APPLICATION FOR AMENDMENT TO  
OPERATING LICENSE

Indian Point Unit No. 3

Docket No. 50-286

July 8, 1977

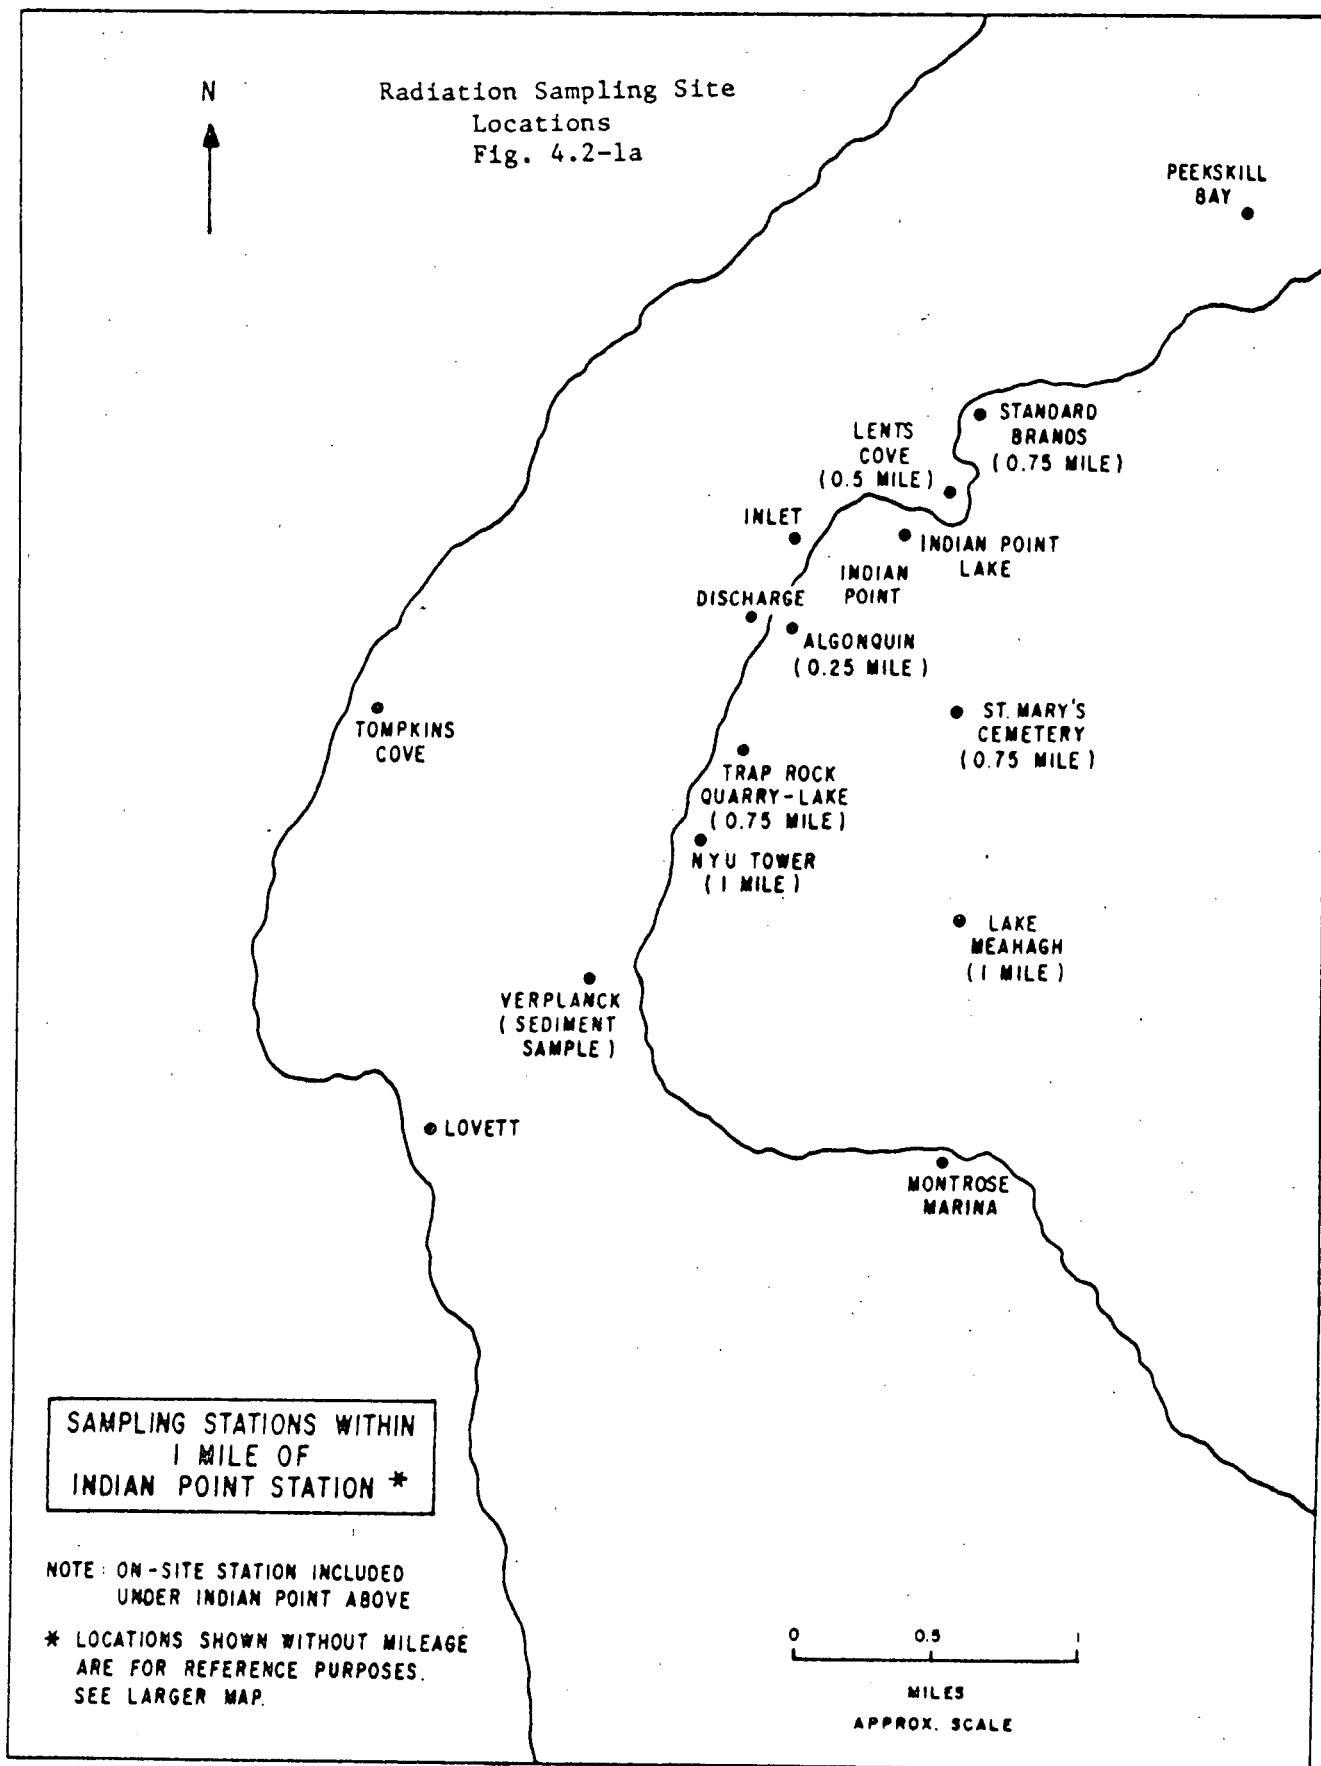
Appendix B, Section 4.2 (see Table 4.2-1, Table 4.2-2 and Figure 4.2-1a) of the site Environmental Technical Specification Requirements contained in Appendix B to the Indian Point Unit No. 3 license requires that a well water sample be collected at sample station point 26 at Verplanck once per calendar quarter. However, the majority of the people living in Verplanck have now sealed off their wells and obtain their drinking water from the New York City Aqueduct. Therefore, a sample of the aqueduct water would be more representative of drinking water for persons living in the area than that of a well water sample.

In view of the above, the Verplanck sample location should be eliminated from the Technical Specifications and replaced with a requirement to sample drinking water from the New York City Aqueduct.
